PROJECT LAYOUT SHEET #83

PROJECT NAME: STOCKBRIDGE-BETHEL
 PROJECT NUMBER: STP 2910(1)
 FILE NAME: z10b214_bdr_nul.83.dgn
 PROJECT LEADER: D.E.G.
 DESIGNED BY: L.M.B.
 IPARM FILE: z10b214183.1

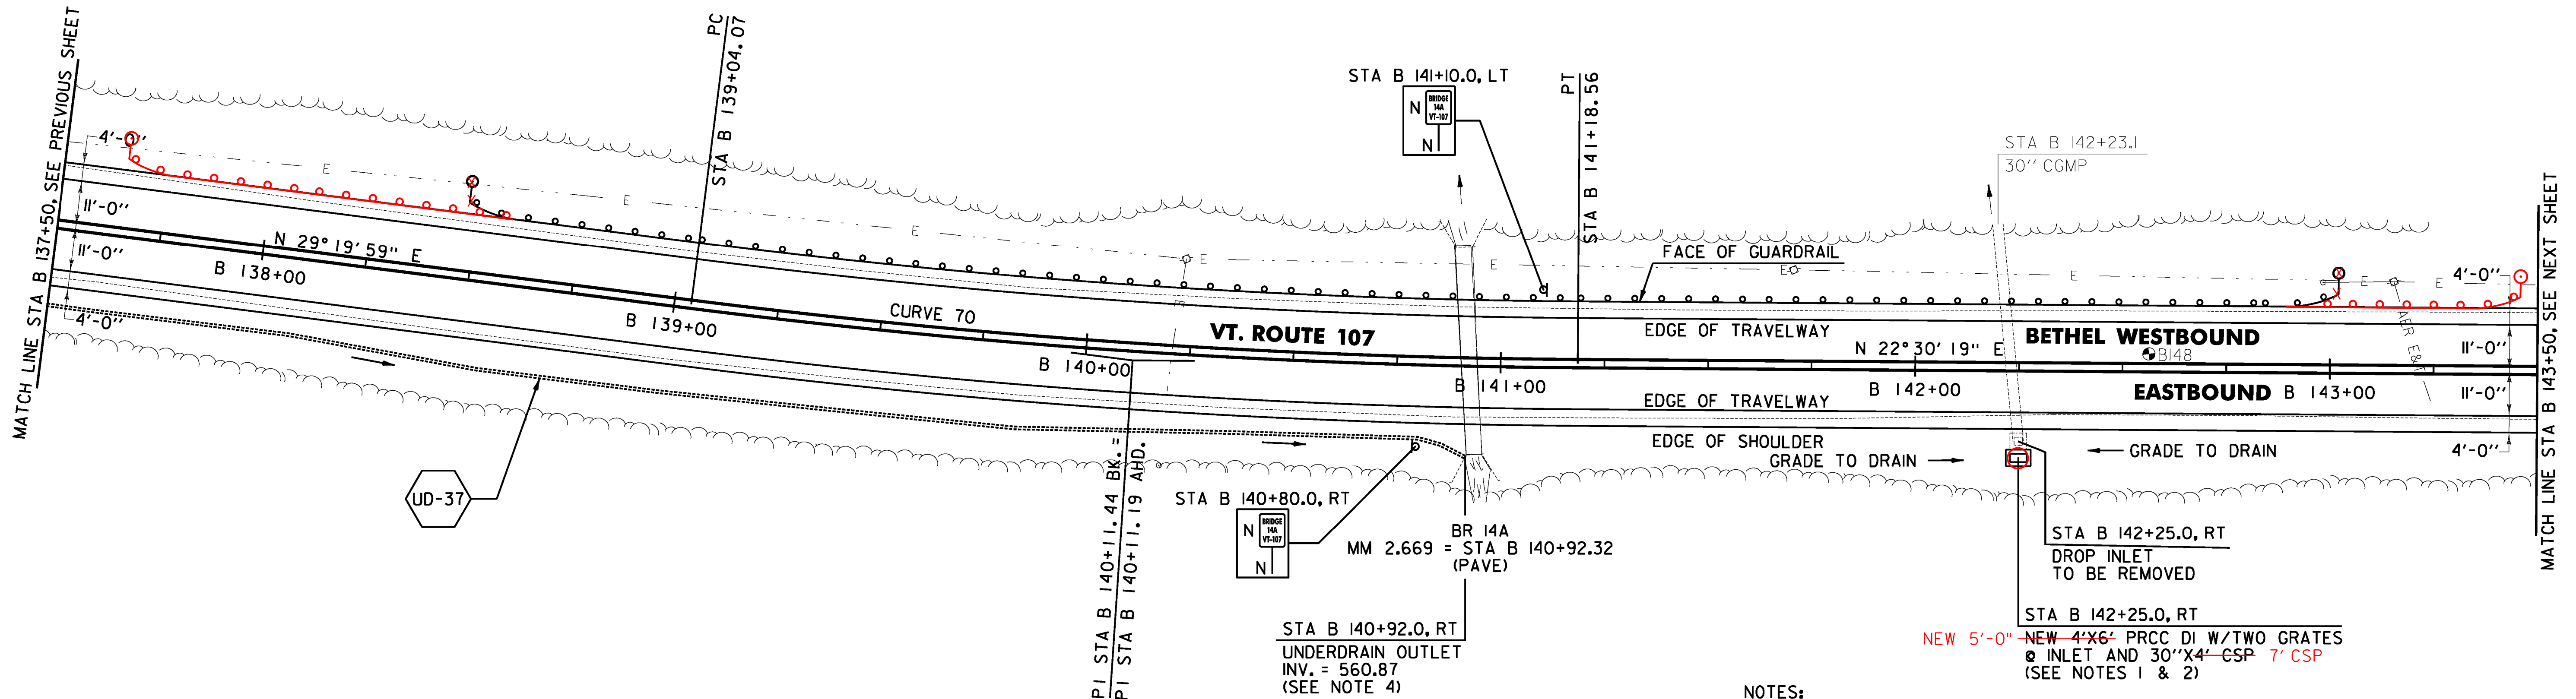
~~646.402 DURABLE 4 INCH WHITE LINE, THERMOPLASTIC OR~~
~~646.404 DURABLE 4 INCH WHITE LINE, POLYUREA~~
 (ALL LINES WILL INCLUDE EDGE LINE BREAKS AND RADIUS FOR TOWN HIGHWAYS)
 BETHEL:
 STA B 137+50.00 - STA B 143+50.00 LT & RT

~~653.20 TEMPORARY EROSION MATTING~~
~~BETHEL:~~
~~STA B 137+50.0 - STA B 141+00.0 RT (85.6 SY)~~
~~STA B 138+50.0 - STA B 140+00.0 LT (63.9 SY)~~
~~STA B 142+00.0 - STA B 143+50.0 LT (68.0 SY)~~
 676.10 DELINEATOR WITH STEEL POST
 BETHEL:
 STA B 138+48.0 LT
 STA B 143+02.0 LT
